The undersigned represents Florida Rock Industries, Inc., the permit applicant in this case. We have been working with Mr. Fred Cohrs of FRI and Mr. Steve Cullen of John Koogler & Associates in reviewing the draft permit, Technical Evaluation and Preliminary Determination, and proposed BACT determination. We have completed our review, and are pleased to submit these comments and suggested modifications and additions.

Applicant: Florida Rock Industries, Inc
Newberry Cement Plant, Alachua County, Florida
DEP File PSD-FL-228, AC01-267311

SUBJECT: K&A 187-94-02
 Florida Rock Industries, Inc.
 Newberry Cement Plant
 Permits Nos. AC01-267311 and PSD-FL-228
 Response to Request for Additional Information, dated 01-AUG-1995

Technical Review of Prevention of Significant Deterioration
 Permit Application for Florida Rock Industries, Inc.'s
 Proposed Cement Plant, Alachua County, Florida

The following calculations to normalize the NOx emission for Florida Rock Plant.

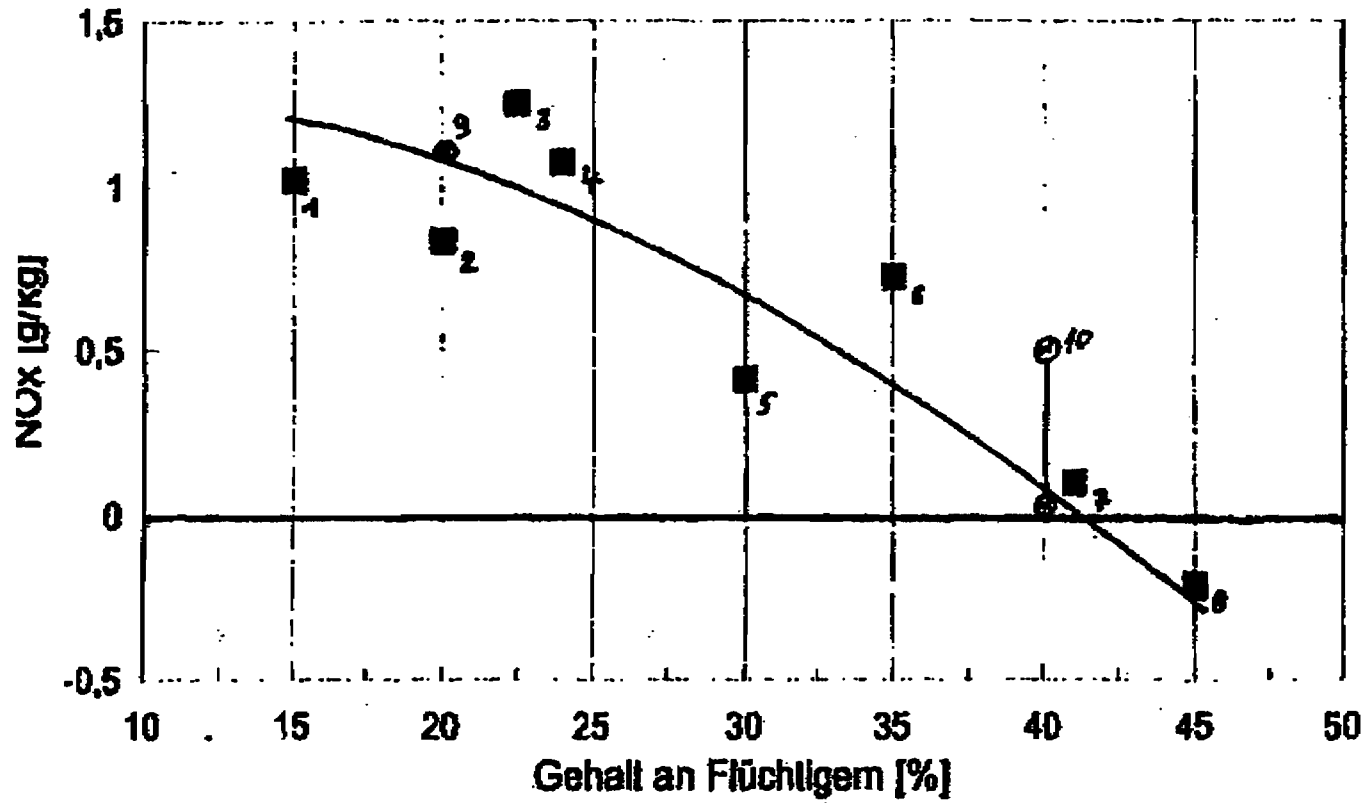
In addition this level should be increased to 3.81 lb/st due to the higher fuel consumption compared to California Calaveras Plant as calculated in the attached.

Additional fuel required	kg/hr	251.2
Percent increased	%	0.08
NOx emission increased	lb/st	3.81
